ADDENDUM No. 03

Date: February 28, 2019

Coaldale Government Building

Project No.: 9030

| | DRG. TITLE: REVISED SECTION 8 AND 9 DELETED CANOPY NORTH OF GL H | | |

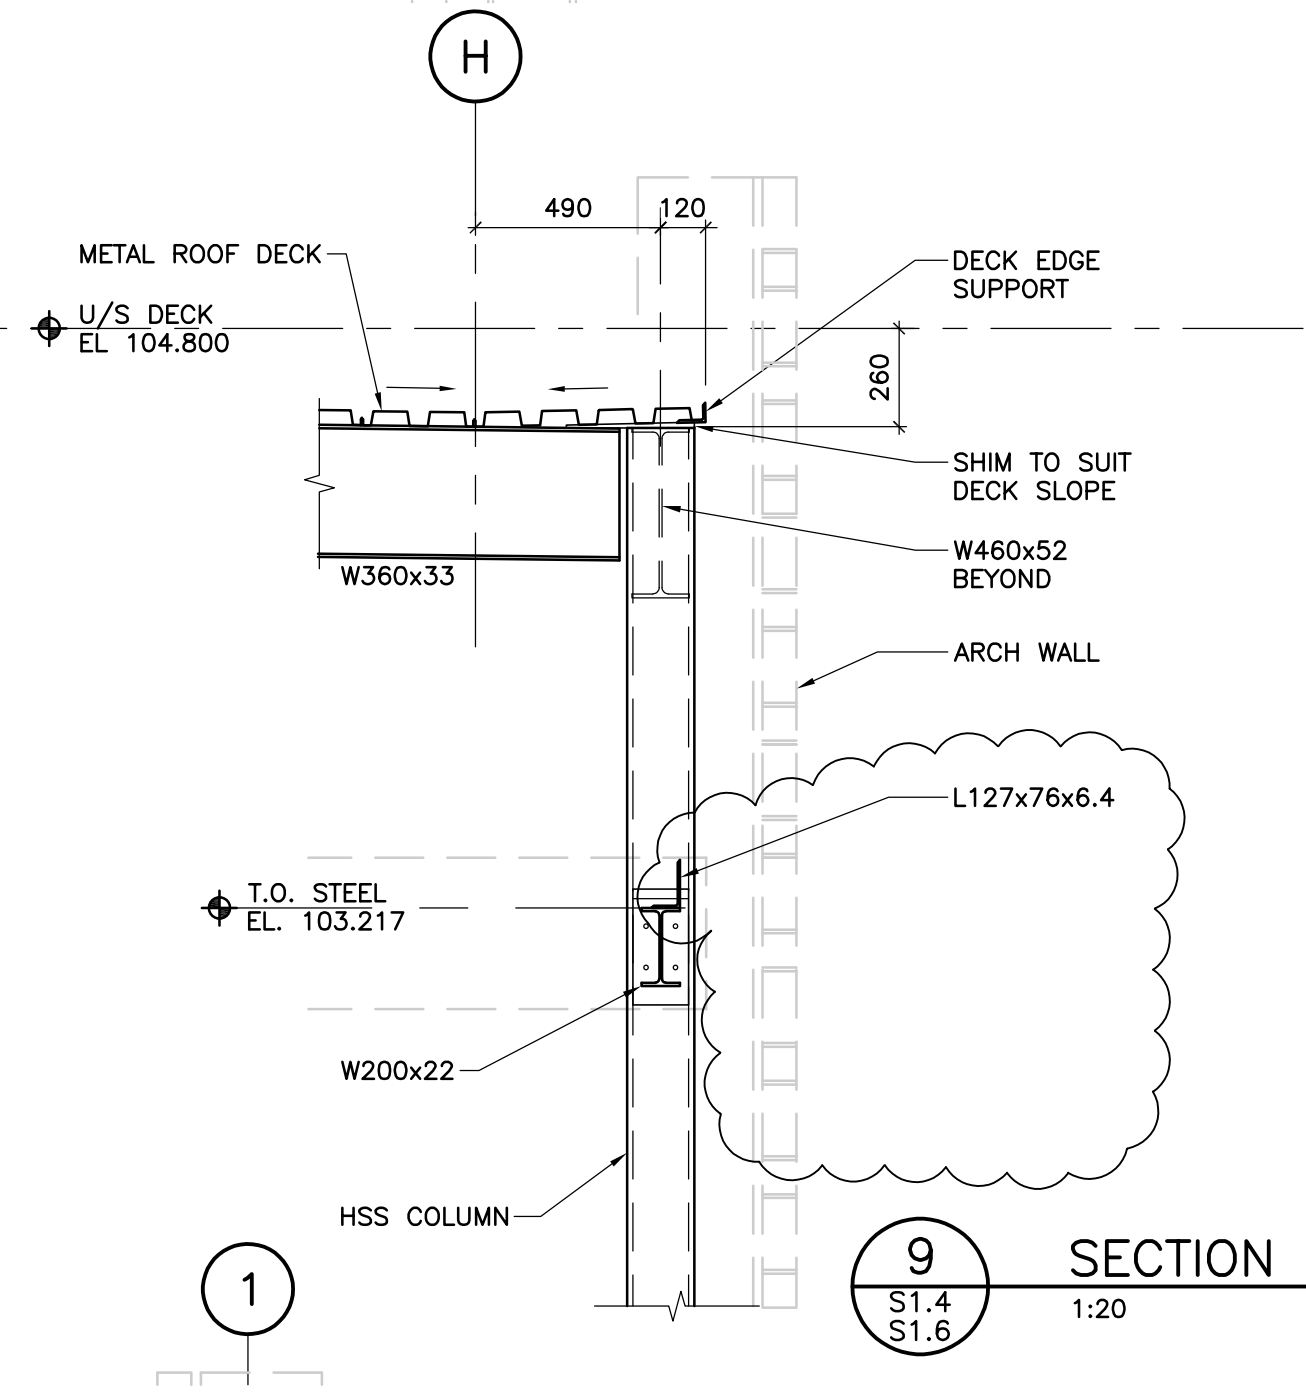
- .5.1 Revise section 8 and 9 as clouded on SSK-015 R1. Deleted canopy at north of gridline H.

| | DRG. TITLE: ADDED STONE VENEER SUPPORT OVER CANOPY FRAMING | | | |

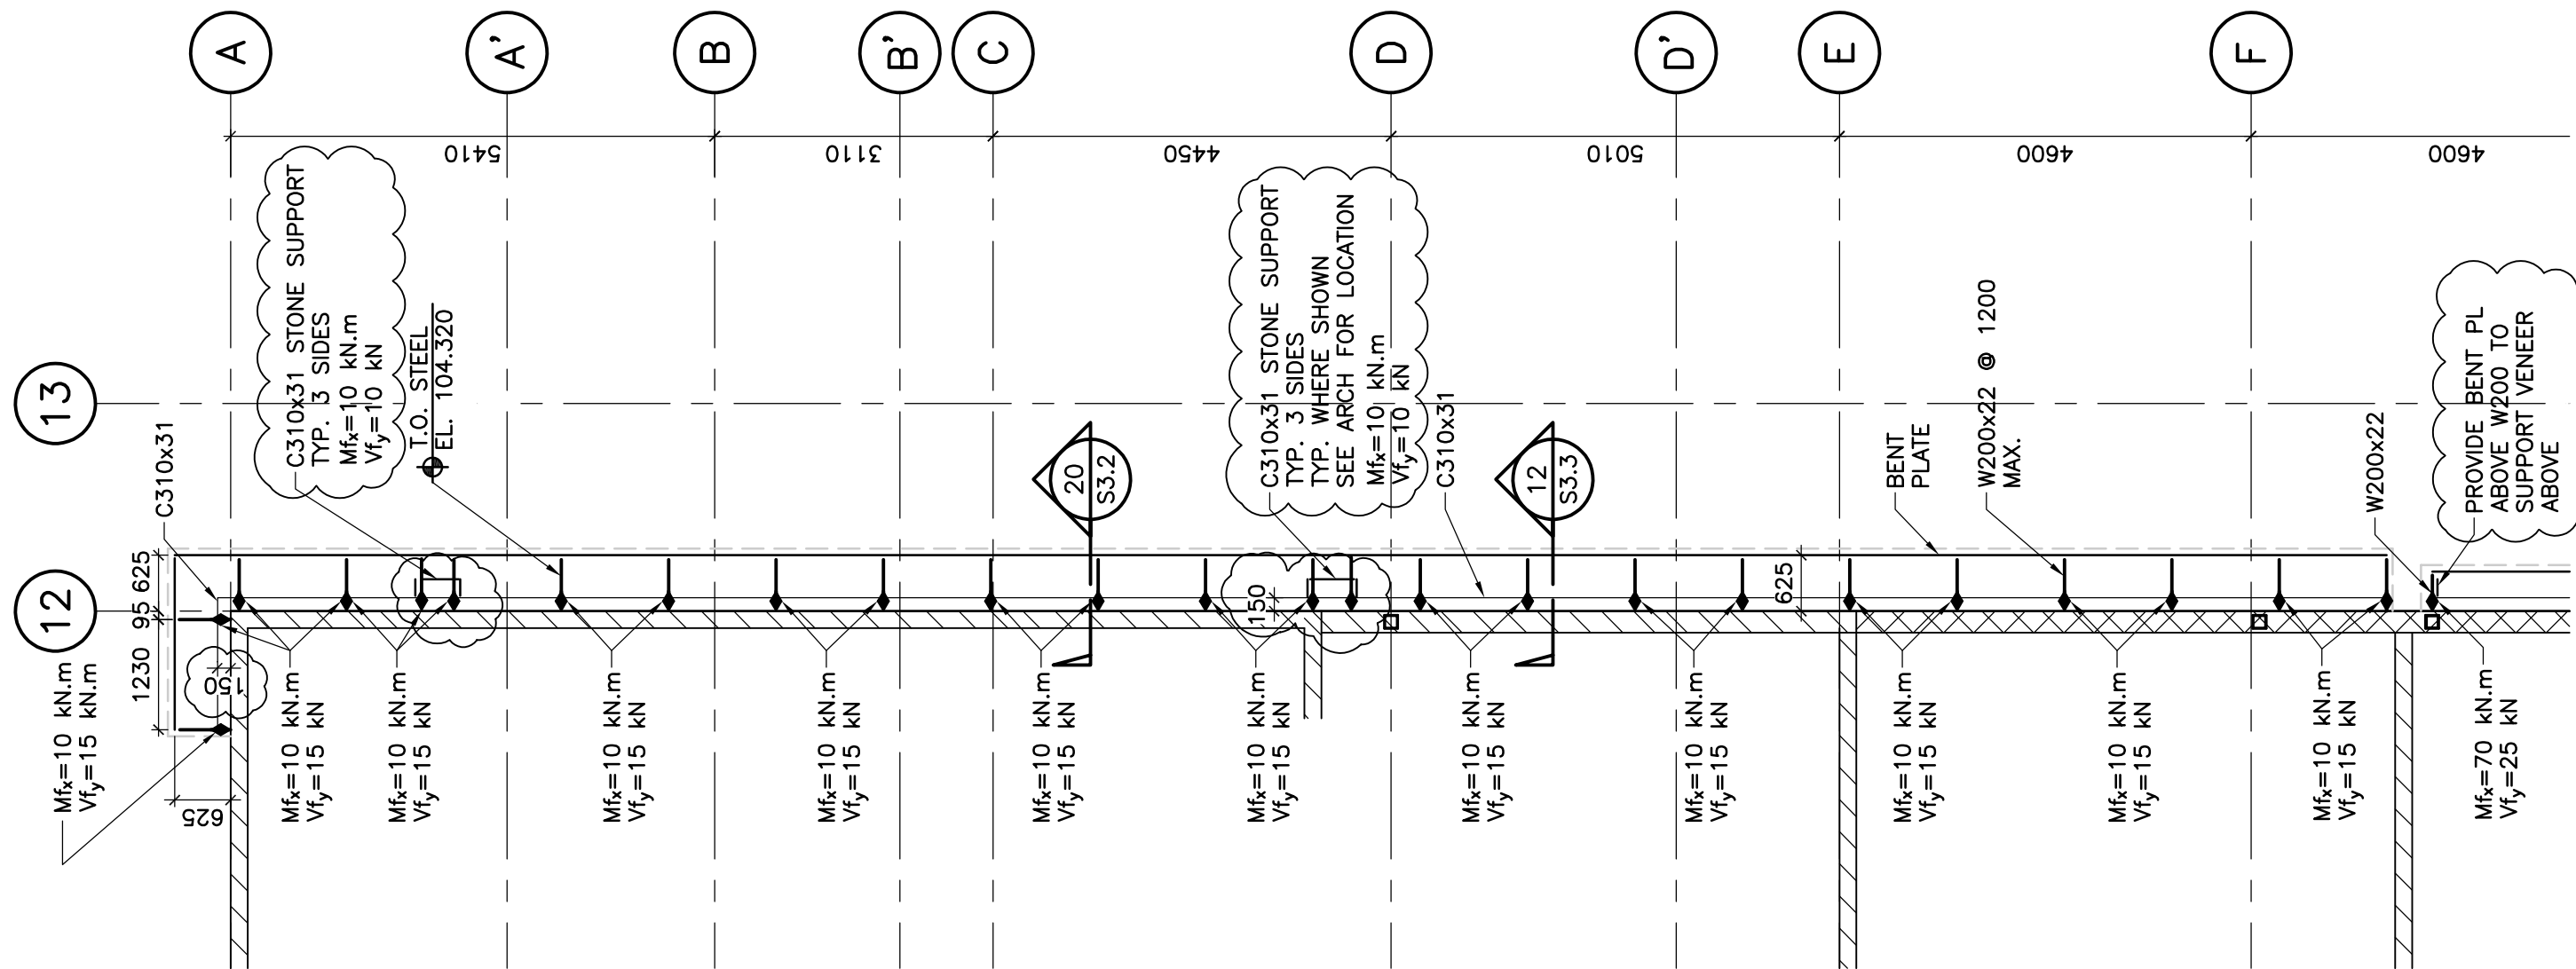
.4.2 Add C310x31 stone veneer support at pilaster above canopy as clouded on SSK-024 R1.

| DRG. TITLE: REVISED DIMENSION ON SOUTH-EAST CANOPY FRAMING PLAN | | | |

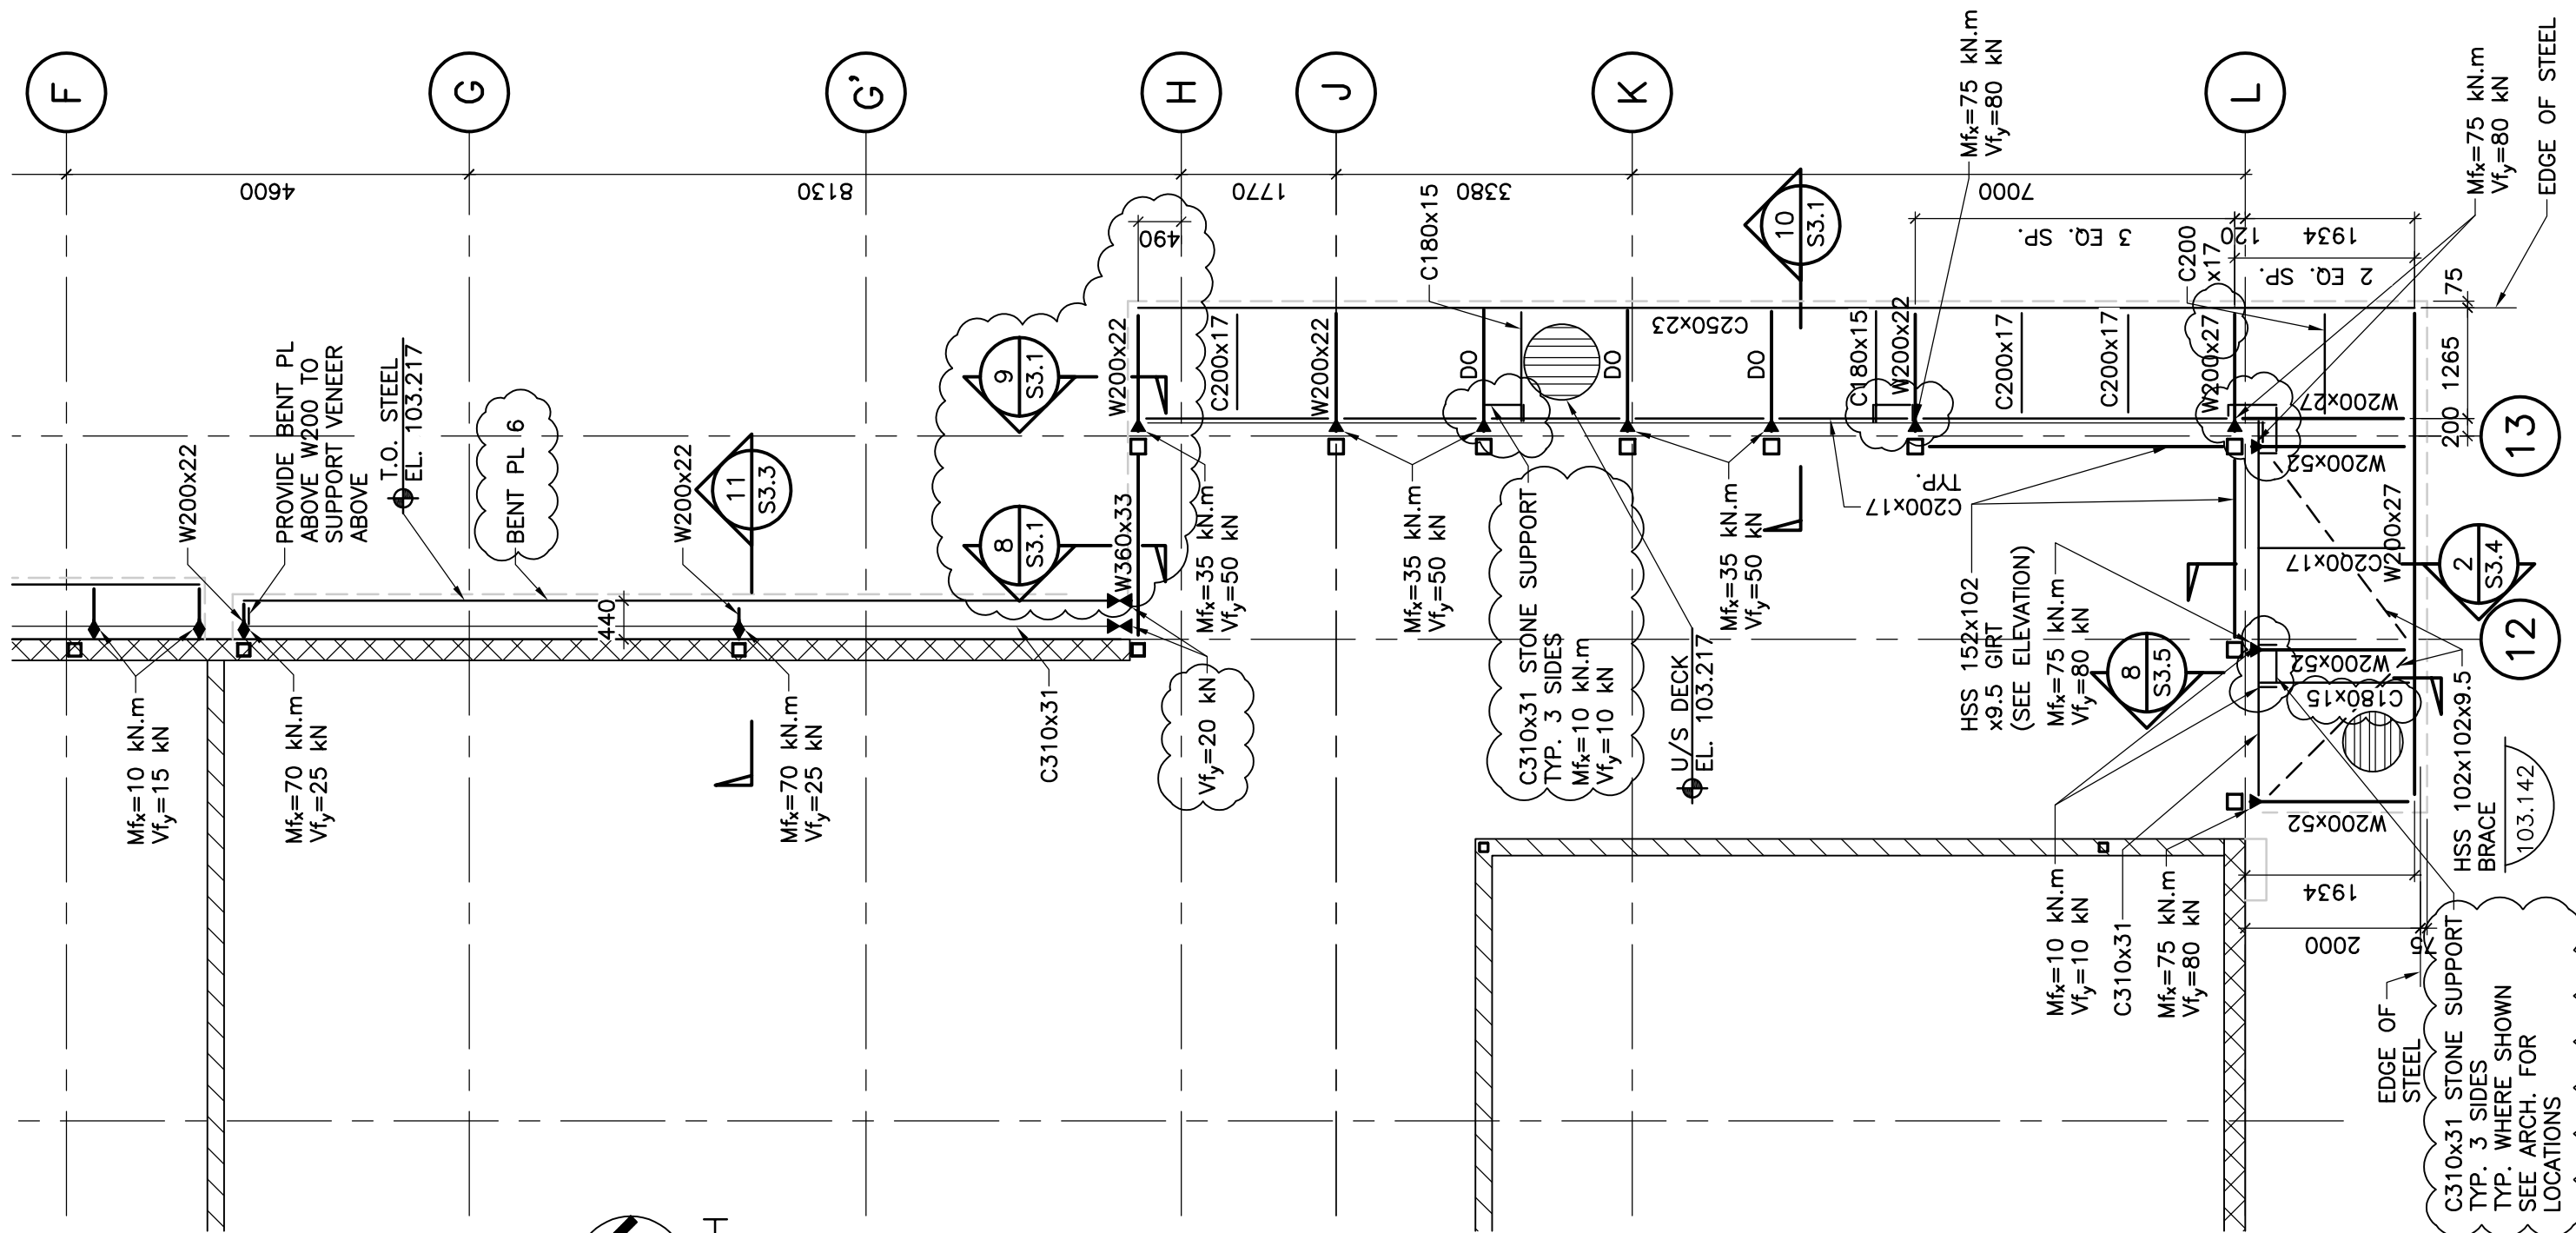
.4.1 Delete canopy framing between gridlines 12 and 13 north of gridline H as clouded on SSK-025 R1.

.4.2 Add C310x31 stone veneer support at pilaster above canopy as clouded on SSK-025 R1.

.4.4 Revise beam W200x22 to read W200x27 along gridline L east of gridline 13 as clouded on SSK-025 R1.

.4.5 Add new section mark 8/S3.5 near gridlines 12/L as clouded on SSK-025 R1.

.4.8 Revise note C250x33 to read 'Bent PL 6' between gridline G and G' as clouded on SSK-025 R1.

DRG. TITLE : REVISED TYP. HOLE IN STEEL BEAM

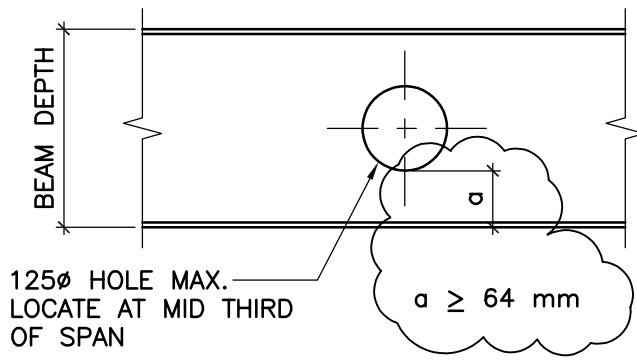
.1.1 Revise 'Typical Hole in Steel Beam' as per SSK-036.

DRG. TITLE: NEW SECTION 8 ON DWG. S3.5

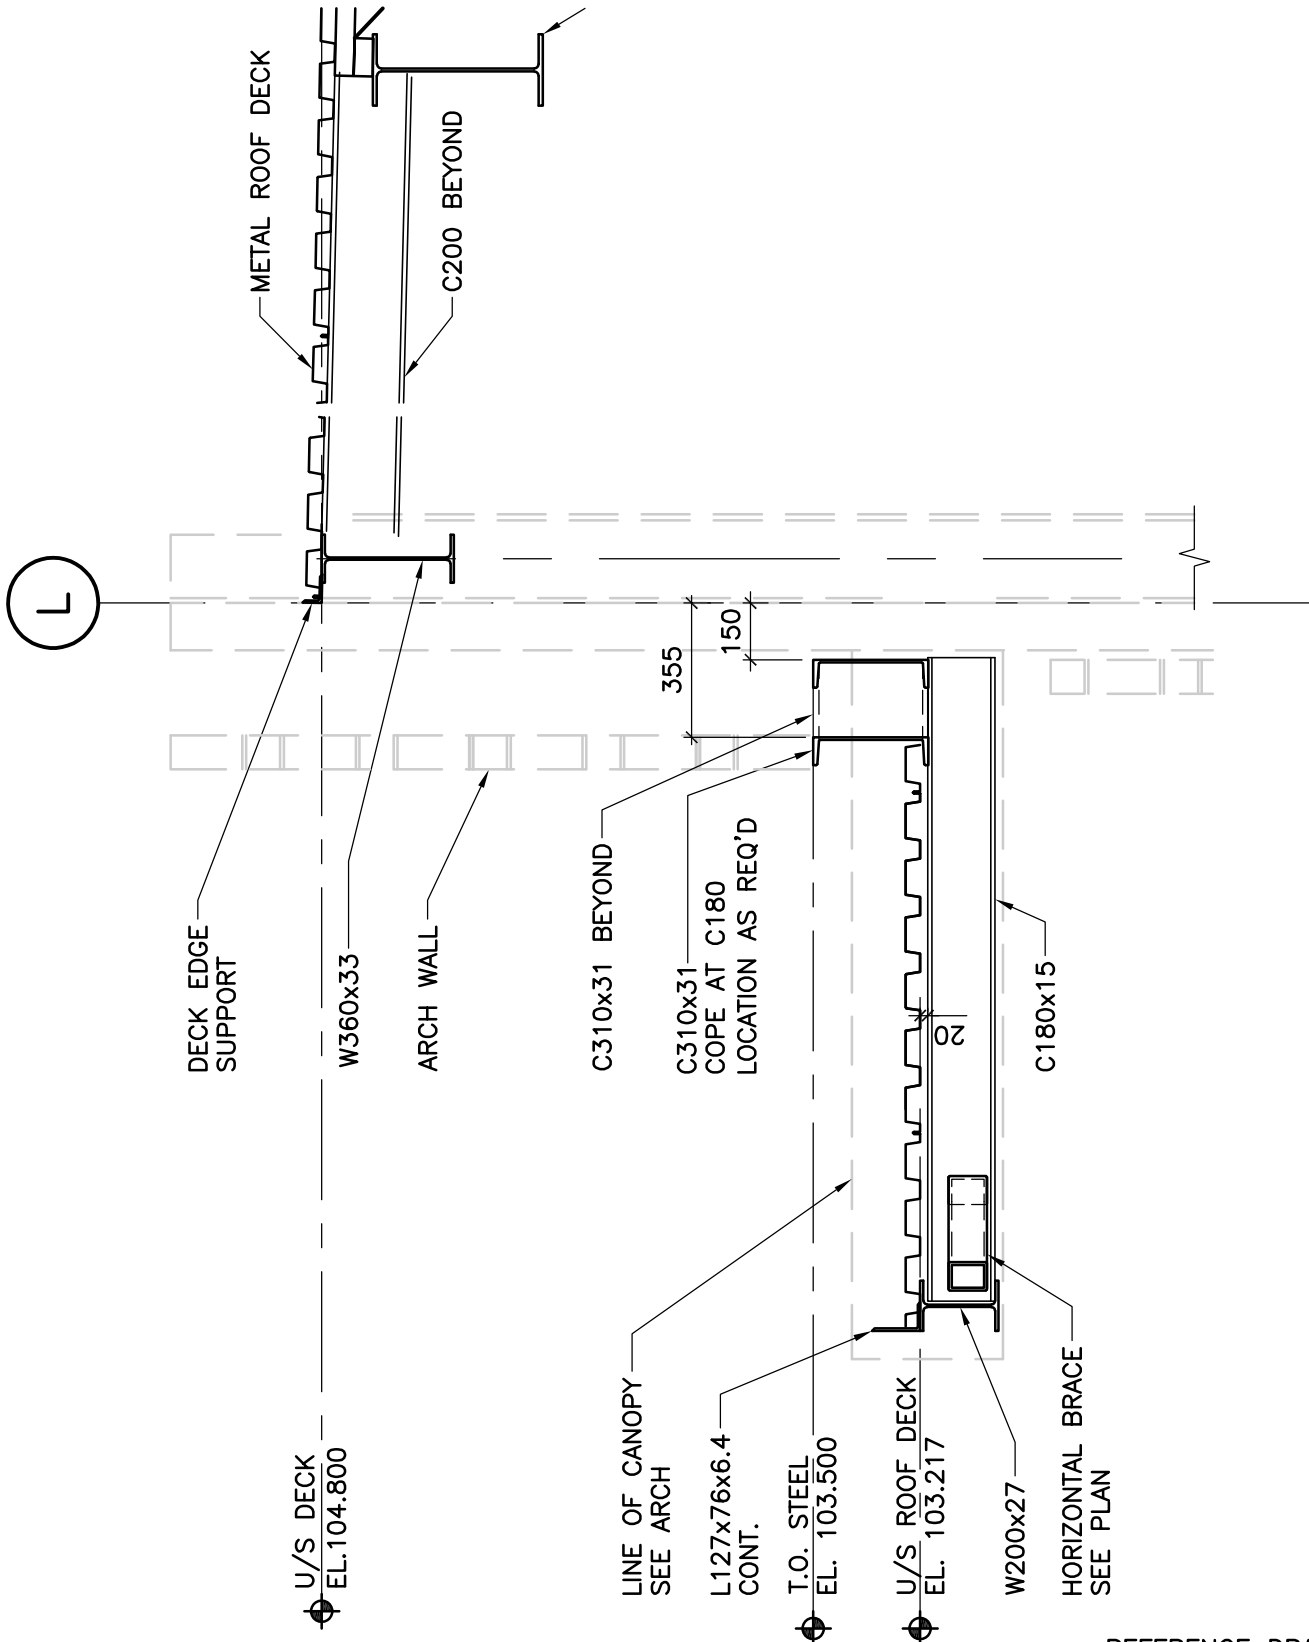
- .7 **Drawing S3.5 Roof Section Sheet 5**
 - .7.1 New section 8 on S3.5 as per SSK-038.
